ITEM NO.: 9

FILE NO.: Z-10134

NAME: Baker Accessory Dwelling – Conditional Use Permit

LOCATION: 4424 Lee Avenue

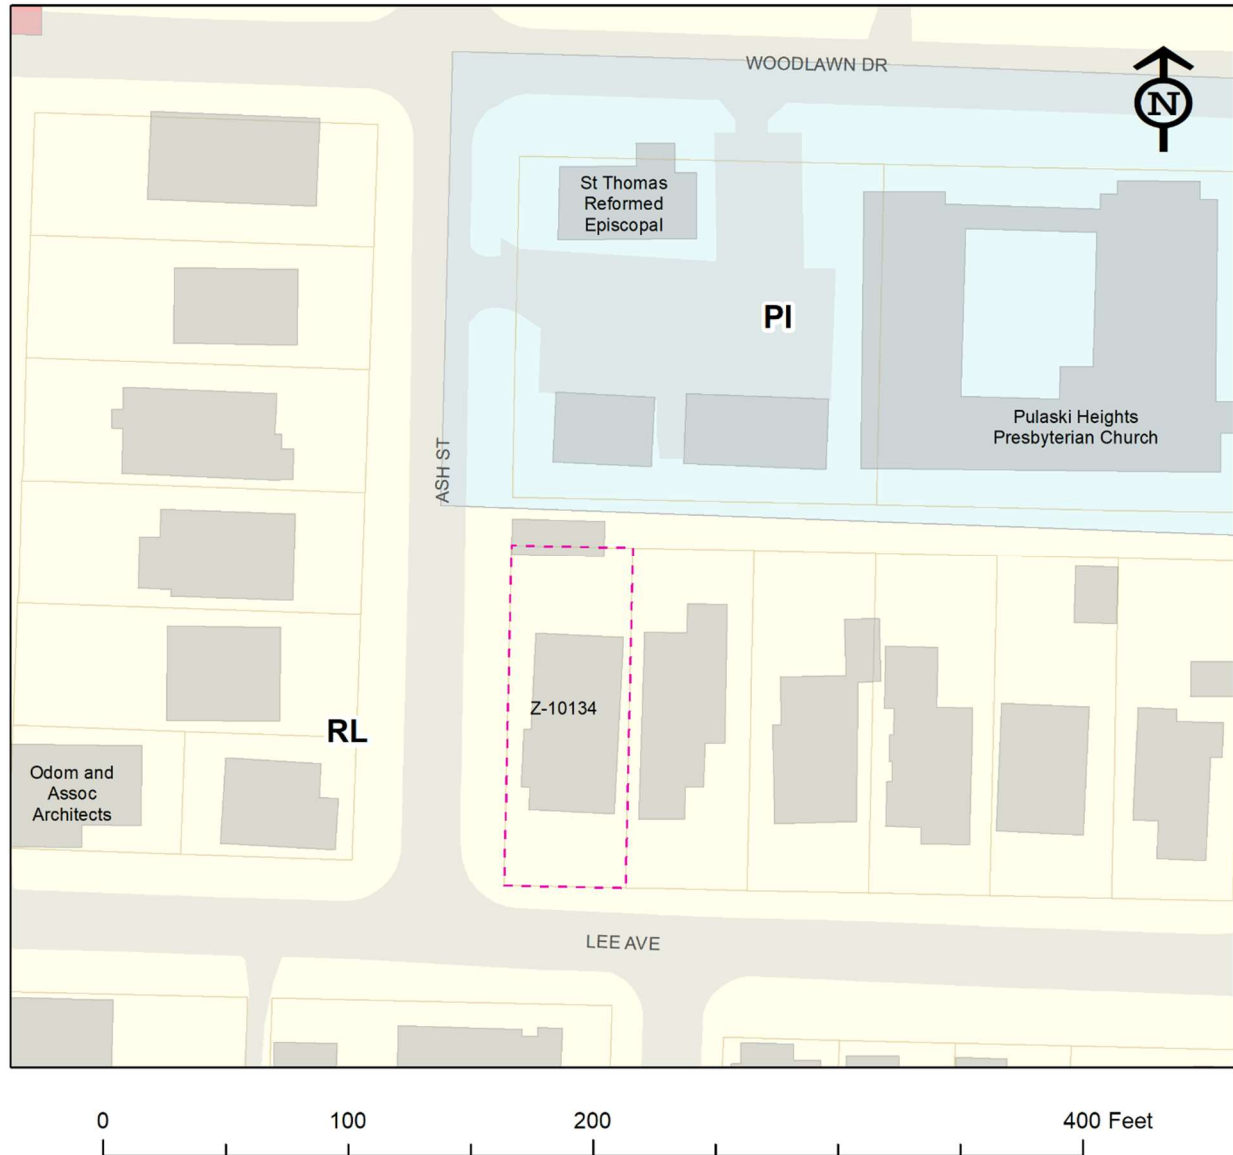
As per 2021 Arkansas Fire Prevention Code Volume III R302.1(1) Single Family Dwellings have the following requirements when dealing with Dwellings that are closer than 7' from the property line:

1. If the soffit assembly extends inside of 5' from the property line, it must be constructed with fire -treated materials. 5/8" Type "X" Drywall, stucco, fire

- treated plywood or some other fire treated material on underside of the soffit, fire treated fascia, elimination of soffit vents and gable vents and crawl space vents on the affected portion of the wall. Note: Vents must be relocated to ensure proper venting of the attic space.

- a. Exceptions to this are to fire block this section of the exterior wall from the top plate to the underside of the roof decking and to fire caulk the blocking at all joints.

2. As per 2021 Arkansas Fire Prevention Code Volume III R302.1(1) Single Family Dwellings have the following requirements when dealing with Dwellings that are closer than 5' from the property line:

- a. Exterior walls from 3 to 5' from the property line must be constructed of 1-hour fire rated material and the soffit must be constructed from 1-hour fire rated material. Soffit and gable vents are not allowed, and venting must be relocated to adjacent roof and wall sections.

- b. Fire Treated roof decking must extend 4' up the roof as per the Authority having jurisdiction.
 - c. In applications 3' to 5' from the dwelling unit to the property line exterior windows are not allowed to exceed 25% of the wall area.

3. **Zero Lot Line Construction** must be processed through Zoning for such allowances. Once processed the following requirements apply.
- a. No part of the footing/foundation is allowed to extend beyond the property line.

- b. No overhang is allowed closer than 2' from the property line and must be constructed from 1-hour fire- treated materials.
 - c. Roof decking must have 4' of fire treated material for the entire length of the wall and turning 4' along the adjacent wall with hip roof construction.

- d. No windows or doors are allowed when the exterior wall is less than 3' from the property line. Windows are required in all sleeping rooms.

Utilities: Utilities are permitted below grade on property but cannot enter where dwellings are located less than 7' from the property line. HVAC Units must be located on dwelling unit property.

1' setback shown – No overhand and fire wall construction required. No windows or doors allowed.

4' setback shown – Fire wall required. Overhand limited to 12"

Other requirements as listed above.
